Re: Comment Response to City of Portland Peer Review Engineer
Harborview Development, LLC – 121 York Street

On behalf of the project team Acorn Engineering, Inc. is pleased to respond to the comments provided by the City Peer Review Engineer dated June 23rd, 2011 by David Senus, P.E. and Ashley Auger, E.I.T. of Woodard & Curran.

UTILITY PLAN
 HARBORVIEW DEVELOPMENT, LLC
 HARBORVIEW DEVELOPMENT, LLC
 PO BOX 8816, PORTLAND, MAINE 04104

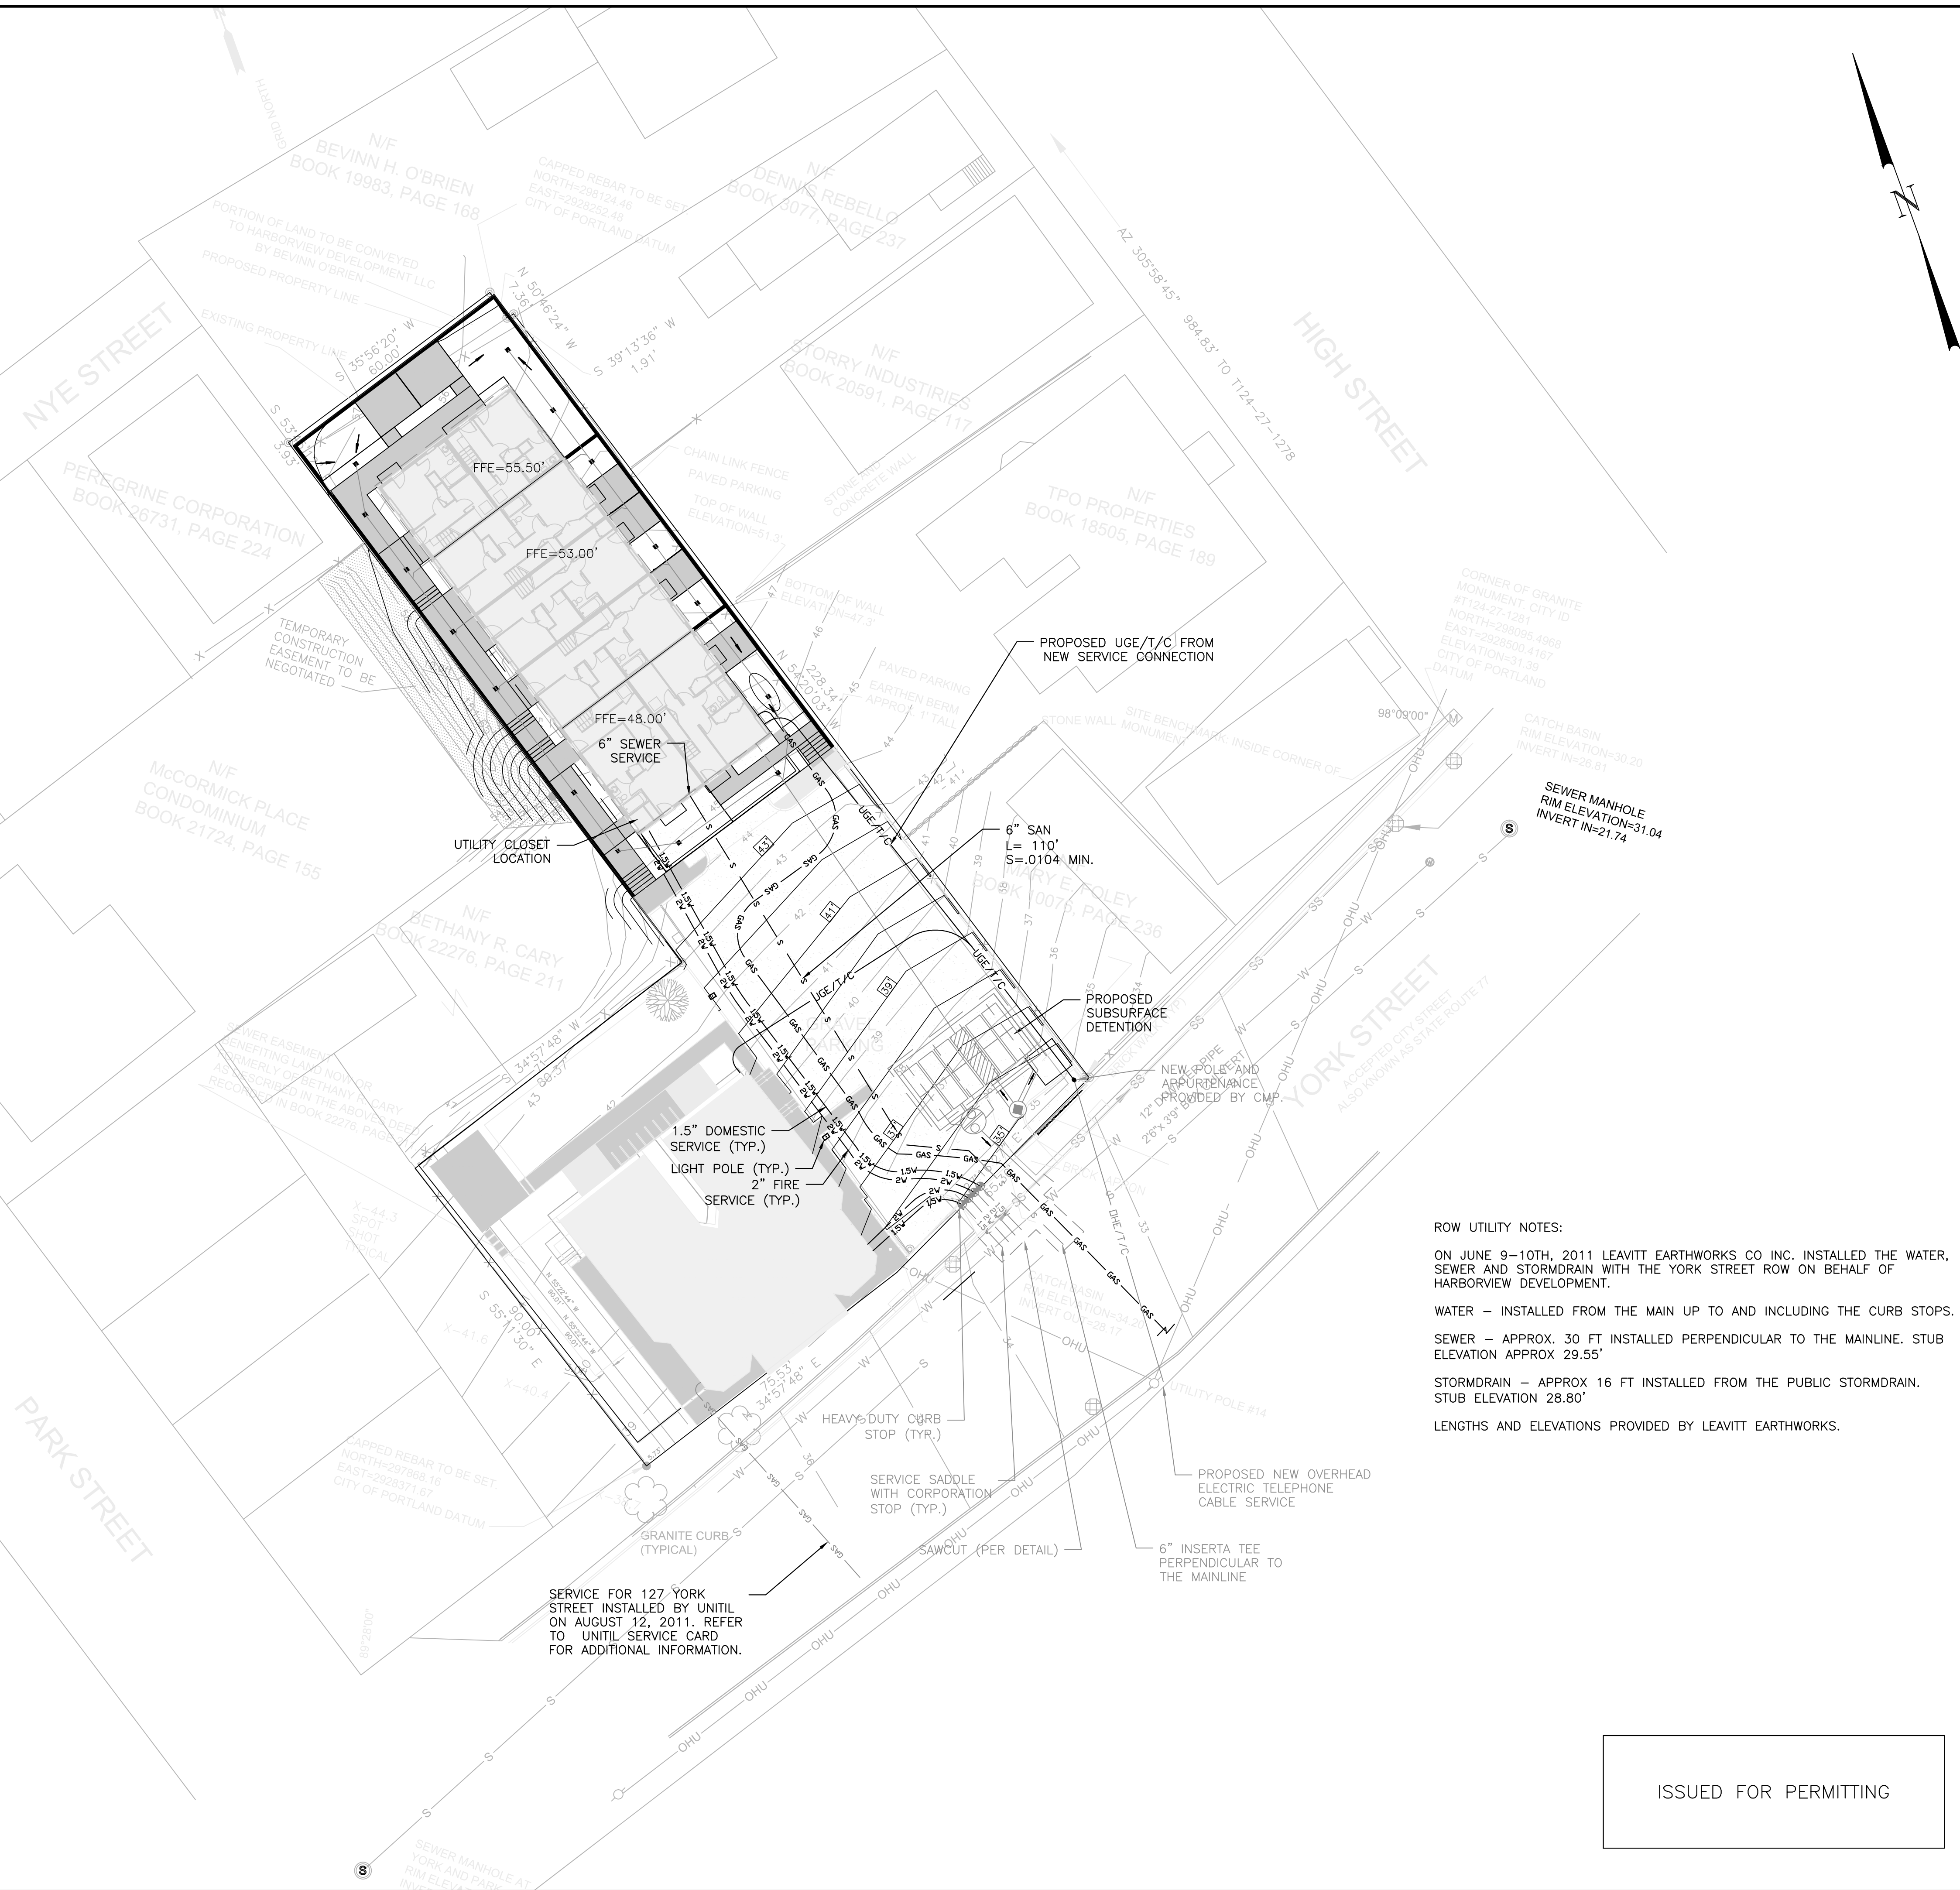
6. *Based on the applicant's response to comments letter, we understand that the utility contractor installed the proposed sewer, water, and storm drain connections within the City ROW on June 9th 10th following approval of this work by Planning DPS. Plans should be updated to the work performed to date, and should clarify how these connections were installed (ie. -The plans currently reflect proposed inserta-tee connections at 45 degree angles to both the sewer and storm drain lines; however, inserta-tees must meet the mainline perpendicular)*

Response: The Utility Plan and Detail Sheet 1 was updated to provide the work performed by Leavitt Earthworks. The installed work within the ROW was differentiated from the proposed on the plans. Length and elevations of provided by Leavitt Earthworks were provided with on the Utility Plan under the header titled, "ROW Utility Notes".

Brian Leavitt of Leavitt Earthworks confirmed that the inserta-tee for both the sewer and storm drain lines were installed perpendicular to the mainline and not at 45 degrees angles as Acorn Engineering previously depicted.

The gas service for 127 York Street was installed by Unitil on August 12th, 2011. The location of the gas line was provided by Unitil and is depicted on the revised Utility Plan.

ROOF / FOUNDATION DRAIN DETAIL

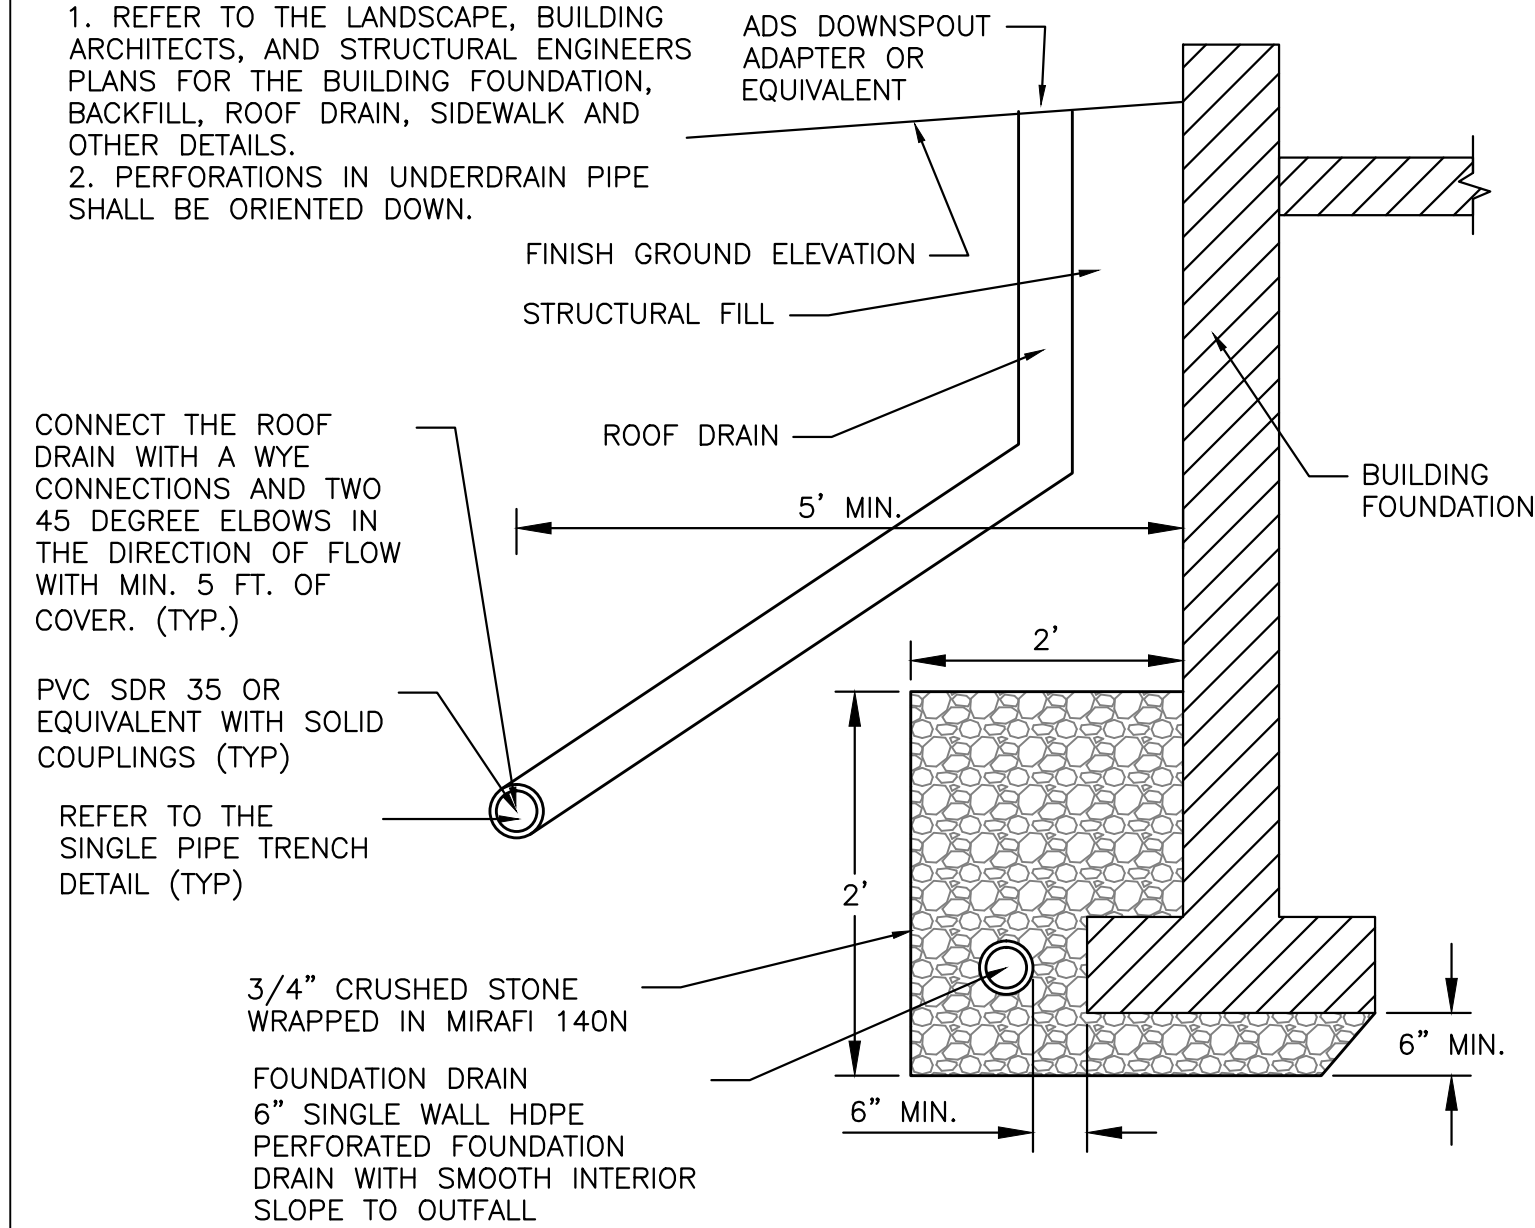
5. *Based on the clarification provided in the applicant's response to comments, we understand the applicant is considering using underdrains with down-facing perforations for the proposed foundation drain system, which will also convey surface drainage from area drains & roof leaders. We also understand that the applicant will coordinate and review the use of the building foundation drain with the project's geotechnical and structural engineers (per applicant's response to comments letter), The applicant should ensure that the design of the underdrain system from a geotechnical and structural building foundation perspective is not compromised by the addition of surface flows into the subsurface drainage gravels.*

Response: Acorn Engineering revised the Grading, Drainage, Erosion & Sed. Control Plan with the addition of the perimeter retaining wall, revised condominium finish floors, and the inclusion of inlet drains within the sidewalk adjacent to the western edge of the building. At such time the inlet and roof drains (surface flows) were removed from the buildings foundation drain. The Roof/Foundation Drain Detail - Detail Sheet 2 was also modified to depict these changes. The inline drain detail was separated into two details. An Inline Drain Detail (Vegetated Areas Only) or Inline Drain Detail (Concrete Areas Only). This was completed at the request of Soren Deniord Design Studio to have a galvanized grate for point drains within concrete areas. The Grading, Drainage, Erosion & Sed. Control Plan was updated to reflect the spot grade, pipe lengths, slopes and elevations. The foundation underdrain and inline drain/roof drain shall tee into one another south of the proposed building below the elevation of the lowest footing elevation. The above changes do not result in an increase to the post development peak stormwater flows. As a result of separating the surface flows from the building foundation drain a review by the project's geotechnical and structural engineer is no longer necessary.
